Access Compliance Report

Public Rights-of-Way

Intersection ID: 42631	Main Street: E_11TH_ST	Cross Street: N_ALEXANDER_ST	Location: W
ADA ID: 55D6ACEC85E8	Ramp Type: PerpDiag	Initial Pass/Fail: Fail	Overall Compliance: No
			Severity Score: 33.75

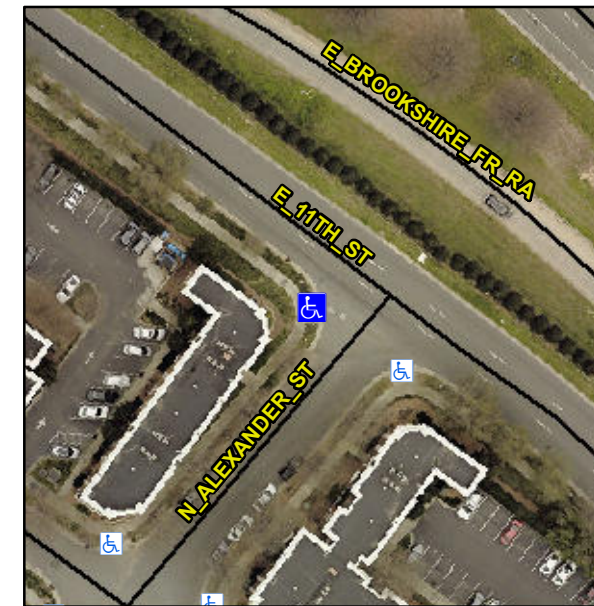
Not Found, R304.5.1, R304.2.2, R304.5.3

Compliance	Description	Data	Compliance	Description	Data
N/A	Ramp Length (in)	72.0	No	Ramp Slope (%)	9.8
No	Ramp Width (in)	41.5	No	Ramp XSlope (%)	6.9
N/A	Flare Type LT	N/A	N/A	Flare Type RT	N/A
N/A	Flare Slope LT (%)	N/A	N/A	Flare Slope RT (%)	N/A
N/A	Flare Traversable LT?	N/A	N/A	Flare Traversable RT?	N/A
N/A	Landing Length (in)	N/A	N/A	DWS Provided?	N/A
N/A	Landing Width (in)	N/A	N/A	DWS Contrast?	N/A
N/A	Landing Slope (%)	N/A	N/A	DWS Length (in)	N/A
N/A	Landing X Slope (%)	N/A	N/A	DWS Full Width?	N/A
N/A	Landing Curb? (Y/N)	N/A	N/A	DWS Offset (in)	N/A
N/A	Shared Landing?	N/A			
N/A	Gutter Ponding?	N/A	N/A	Gutter Slope (%)	N/A
N/A	Gutter Lip Ht (in)	N/A	N/A	Gutter X Slope (%)	N/A
N/A	Painted X Walk1?	No	N/A	Painted X Walk2?	No
	X Walk 1 Direction	To SE		X Walk 2 Direction	To NE
N/A	X Walk 1 Width (in)	N/A	N/A	X Walk 2 Width (in)	N/A
	X Walk 1 Slope (%)	9.4		X Walk 2 Slope (%)	3.4
	X Walk 1 X Slope (%)	1.0		X Walk 2 X Slope (%)	9.9

Remove & Replace Curb Ramp With Two New Directional Ramps or Equivalent.
